ISSUE−2

PARTY'S NAME	PHILIPS INDIA LIMITED, GURGAON
PARTY'S DRAWING No.	AS PER DRAWING
ALLOY & TEMPER	6063 T6
DESCRIPTION	HEAT SINK SECTION (TUBE LIGHT)

DRAWING No.	SECTION No.
P−13455	−
E0155	E0155(ISSUE−2)

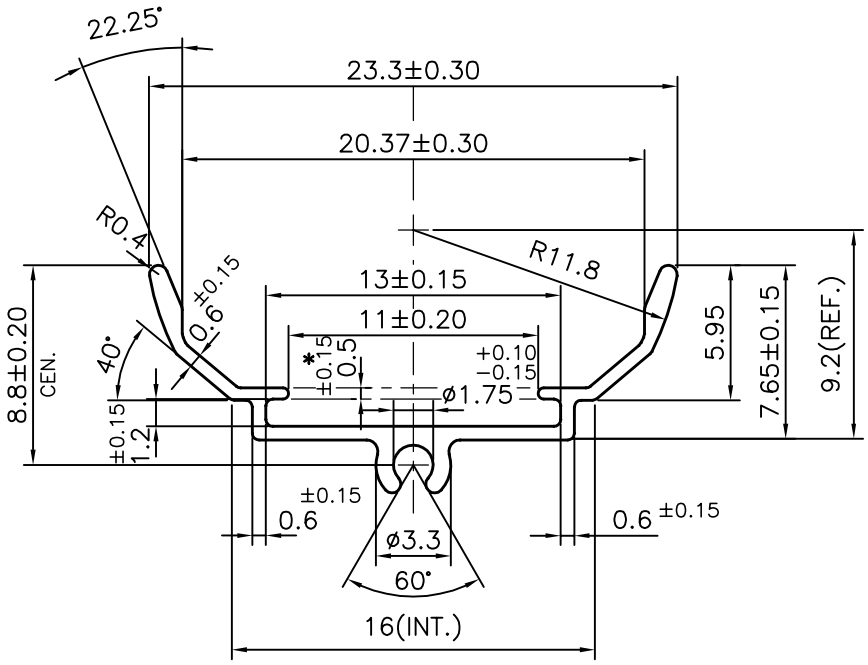
** = CRITICAL DIMENSION TRY TO MAINTAIN IT CLOSE TO THE NOMINAL 0.5mm*

THICKNESS CHANGED 0.60 mm TO 0.50 mm & TOLERANCE ADDED 0.5±0.15

WEIGHT ALSO CHANGED FROM 0.074 Kg/M TO 0.072 Kg/M
